ADDENDUM 04
DELAWARE TECHNICAL & COMMUNITY COLLEGE
ALLIED HEALTH – C-WING ADDITION & RENOVATIONS

January 29, 2013

Project Name: **Delaware Technical & Community College – Allied Health, “C” Wing Addition & Renovation**

Subject: **ADDENDUM 4**

**ADDENDUM #4 BASE
BID ROOMS C144
AND C146 VCT
PATTERN**

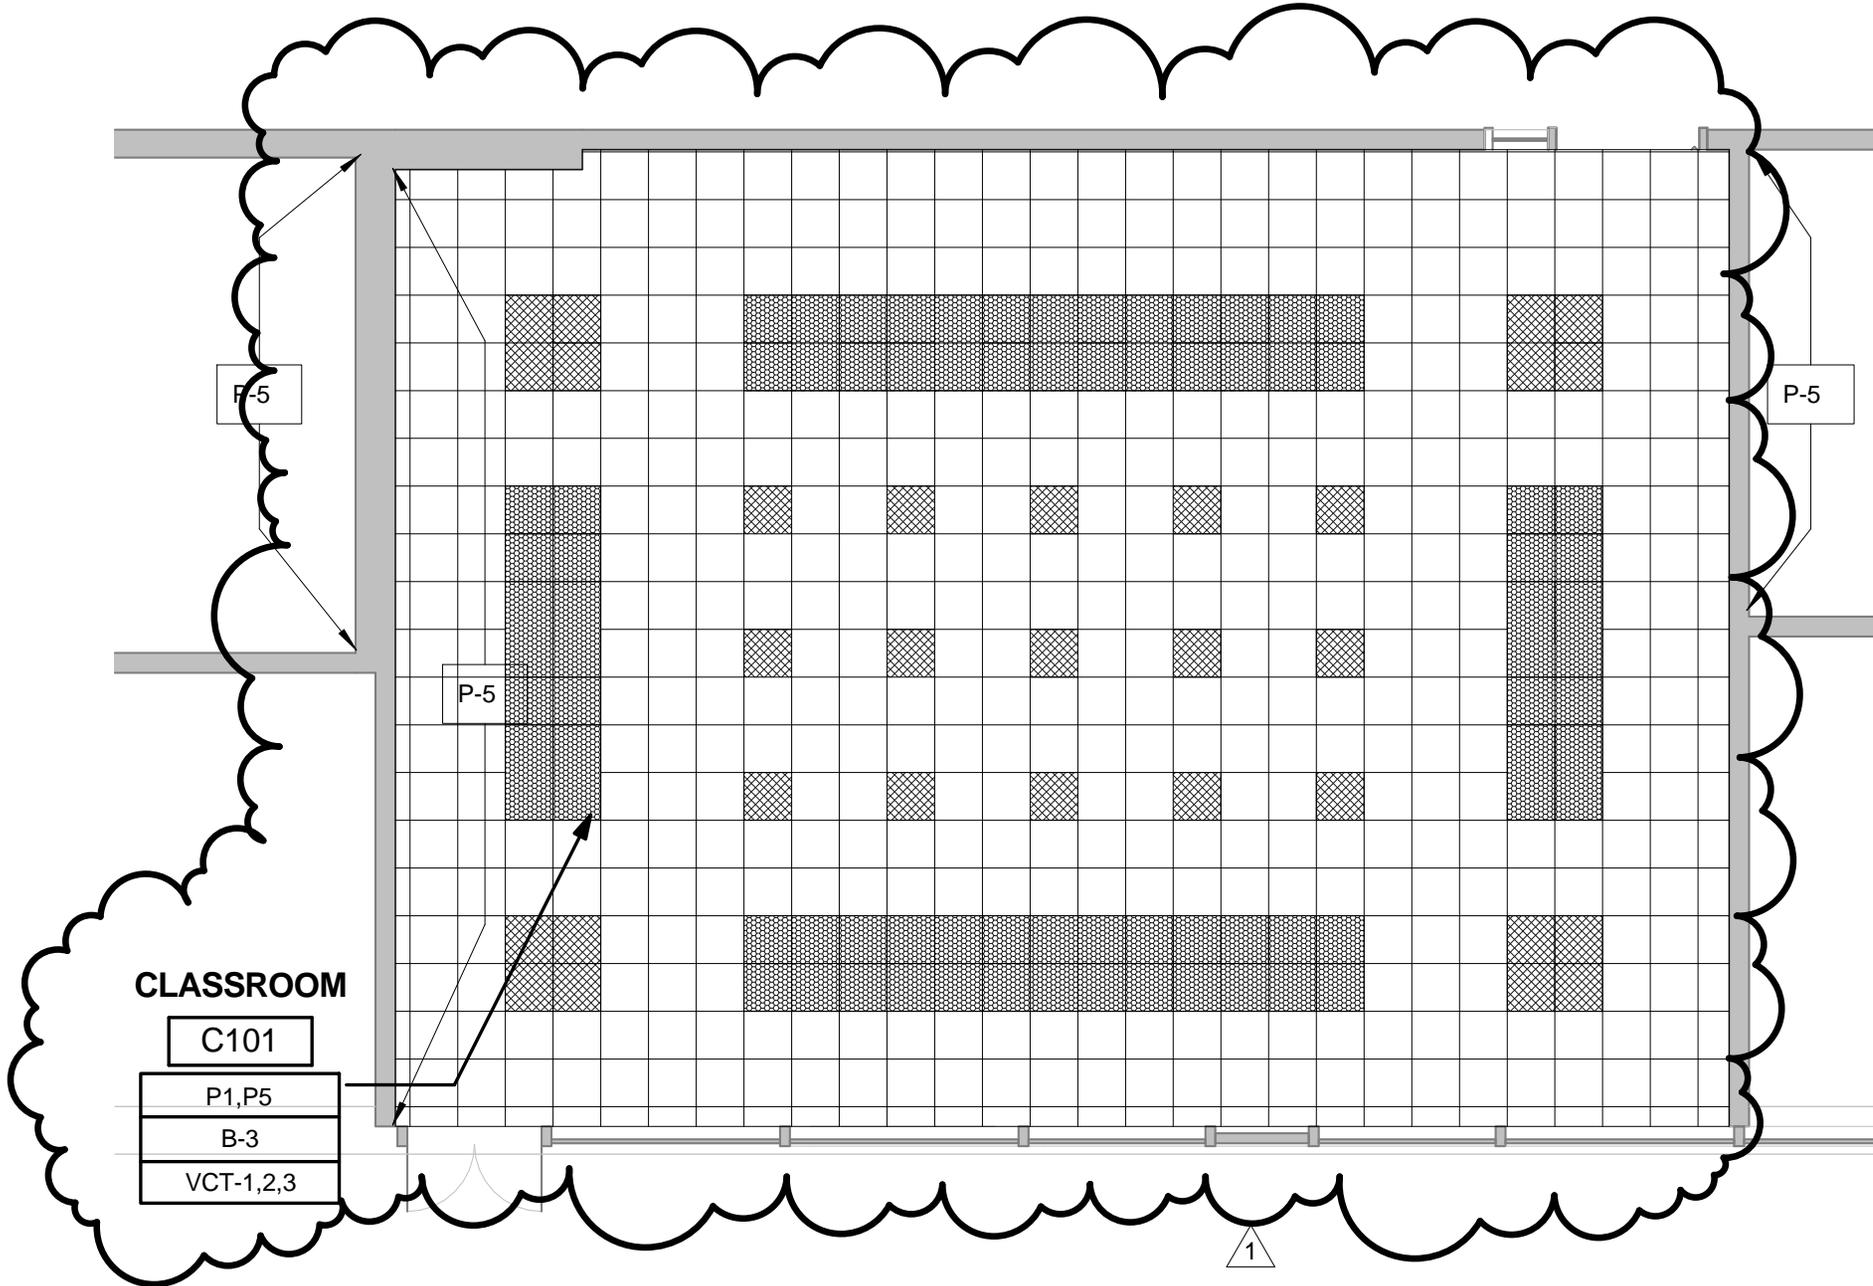
Reference:	A132	Sheet:	ASK-020
------------	------	--------	---------

**ADDENDUM #4 ALT #4 ROOM
C101 VCT PATTERN**

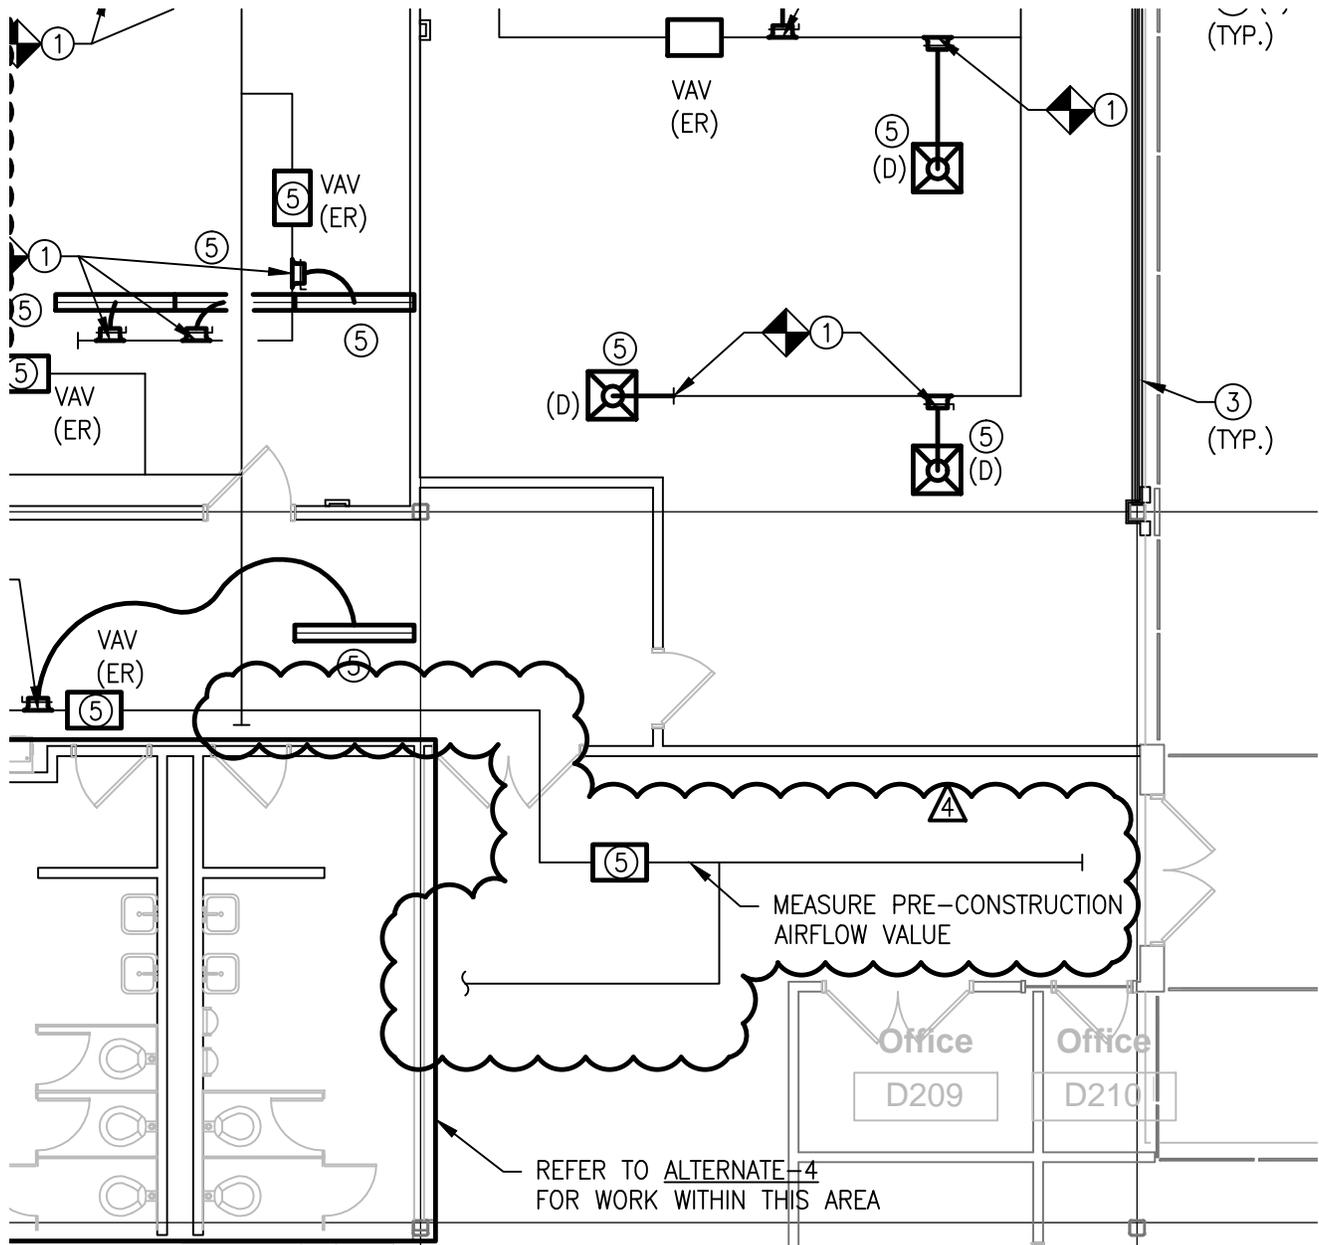
Reference:	A135-A4	Sheet:	ASK-021
------------	---------	--------	---------

Reference: M102-A6 Sheet: MSK-010

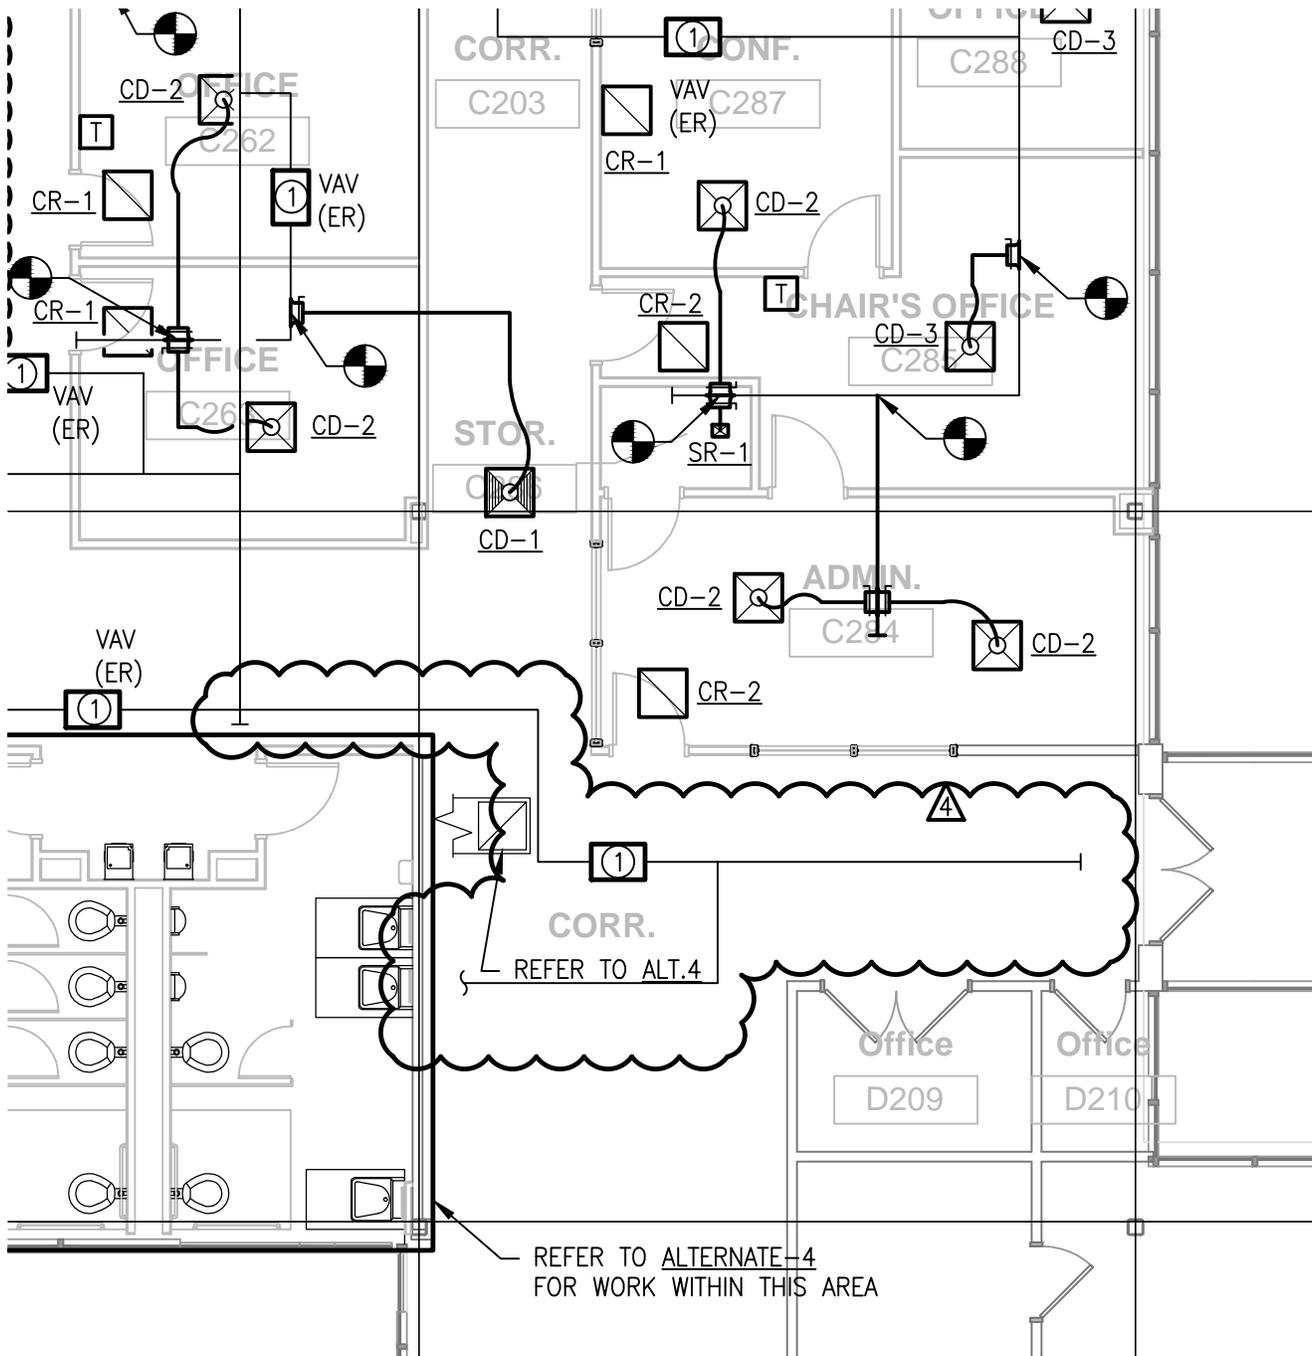
D-6	Drawing M102-A6: a.) Measure airflow of VAV box shown prior to construction. Refer to sketch MSK-010 .
D-7	Drawing M114-A6: a.) Balance duct main, and VAV box to pre-construction airflows. Refer to sketch MSK-011 .
D-8	Drawing M101-A7:

Reference:	M101-A7	Sheet:	MSK-012
------------	---------	--------	---------

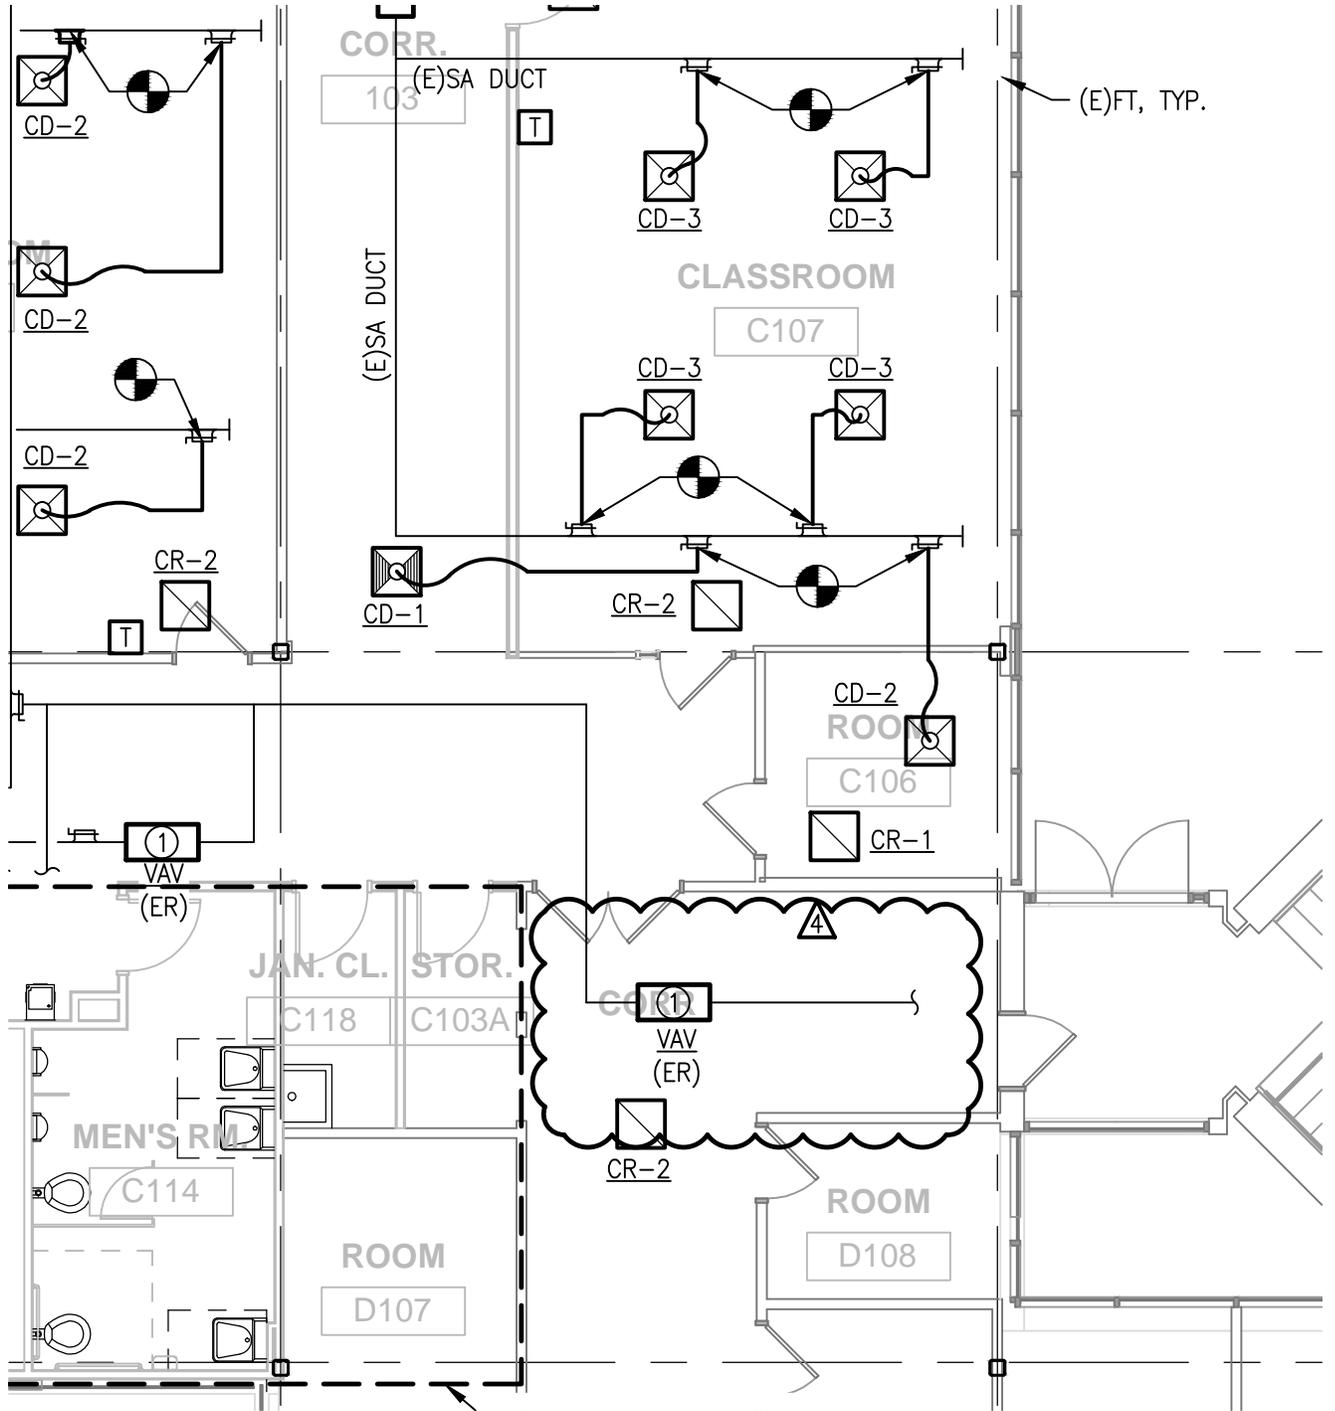
a.) Measure airflow of VAV box shown prior to construction. Refer to sketch MSK-012.
D-9		Drawing M112-A7: a.) Balance duct main, and VAV box to pre-construction airflows. Refer to sketch MSK-013.
